Product Change Notification: PCN-22-158534

**General Product Description:**  
 MODULAR JACK, RJ45, SMT TYPE,AU:6u"

Drawing Error Correction

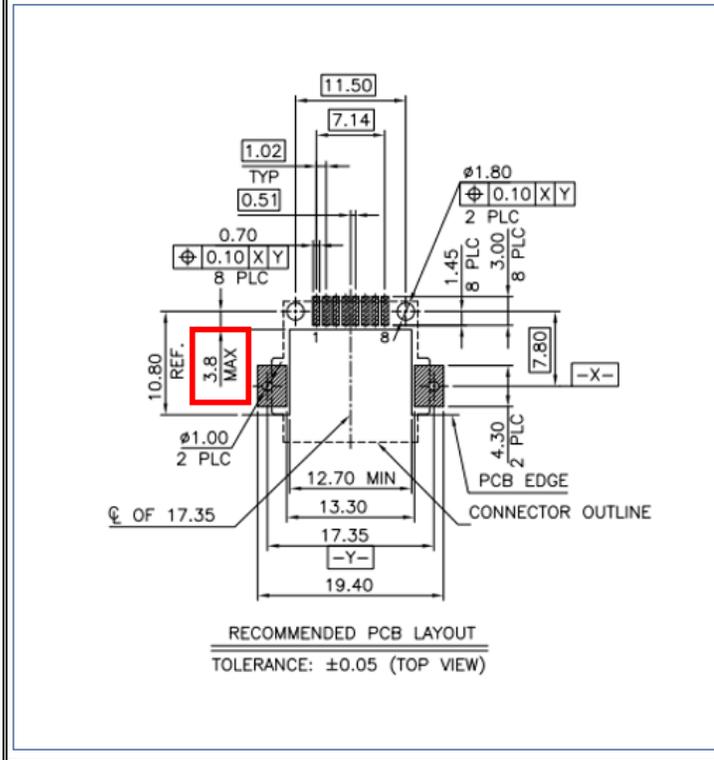
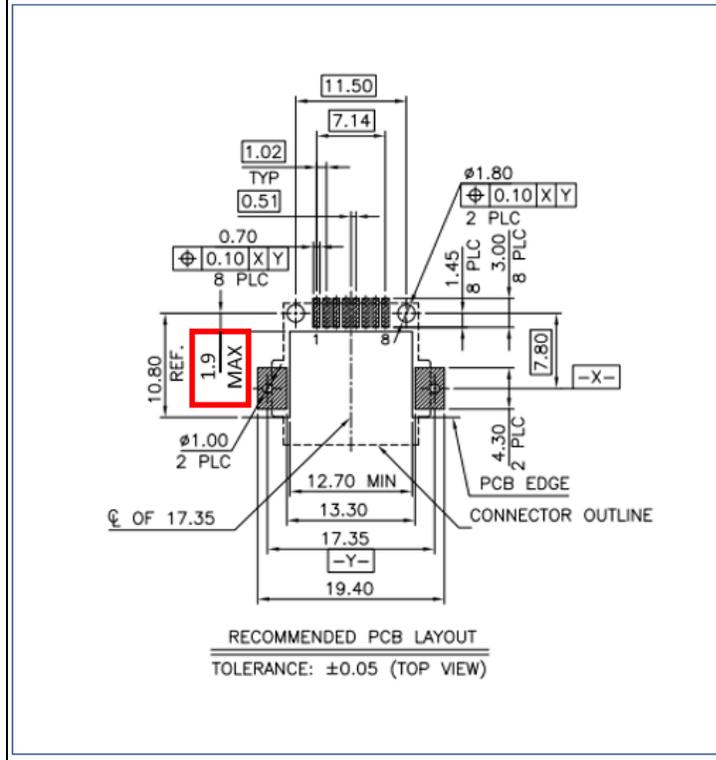
Distance between mounting hole position and mid mount edge is 3.8mm MAX

Distance between mounting hole position and mid mount edge will be 1.90mm MAX
